ADDENDUM No: #1

PROJECT: Novi Community School District
2020 Bond Athletics Bid Package No. 1: Novi Middle School

DATE: April 20, 2020

1 EXISTING ELECTRICAL PANEL
N.T.S.

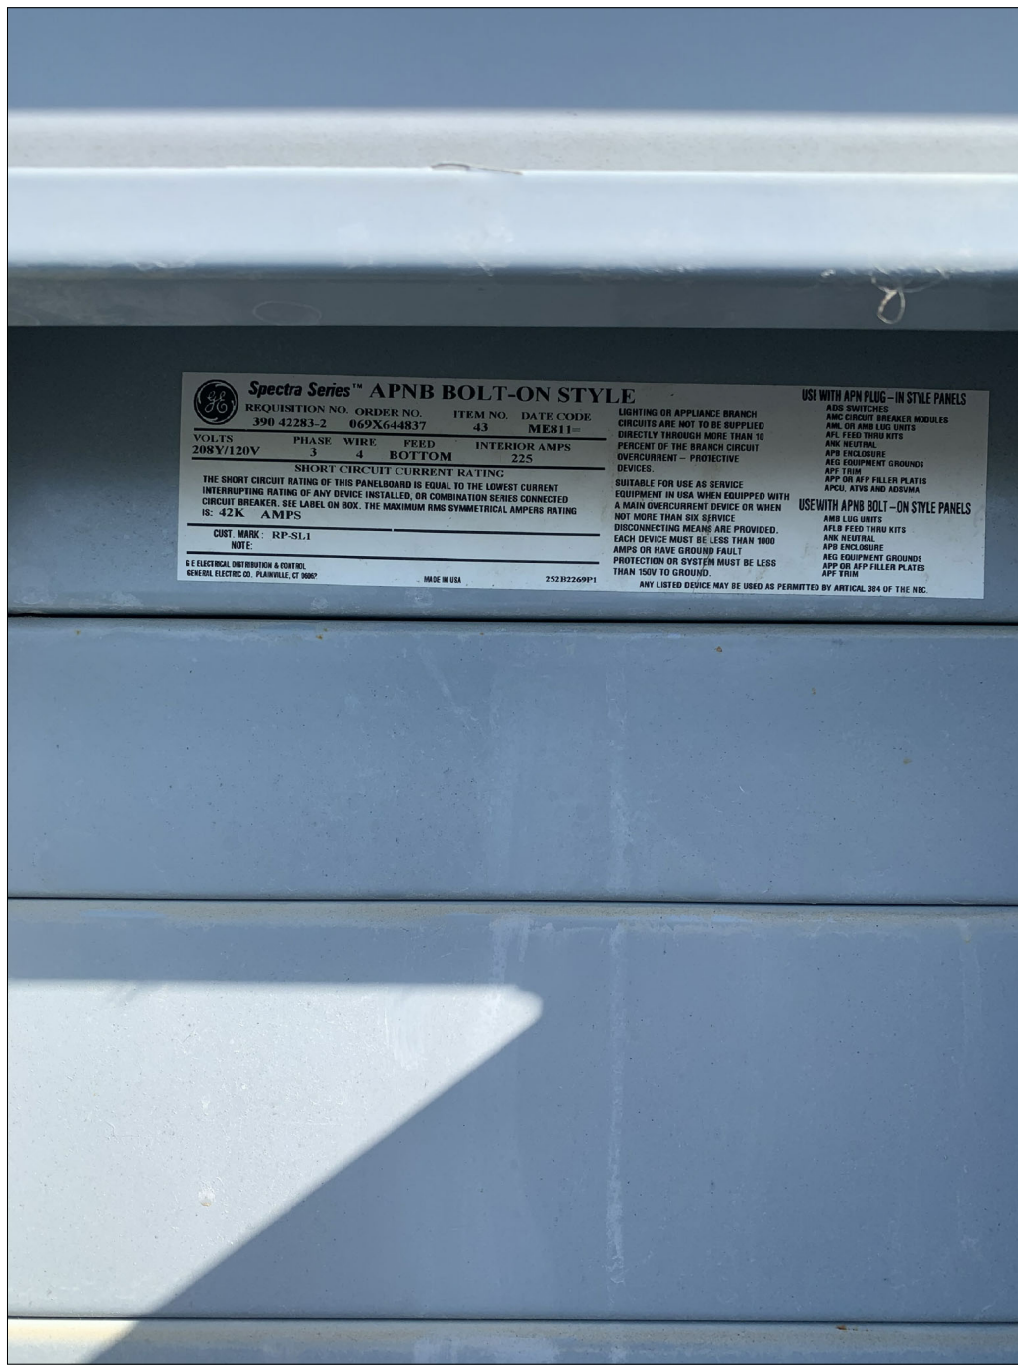
DC-1 **Insert Revised Sheet L1.01 Existing Conditions and Demolition Plan**

A. Revised sheet includes pictures of existing electrical panel
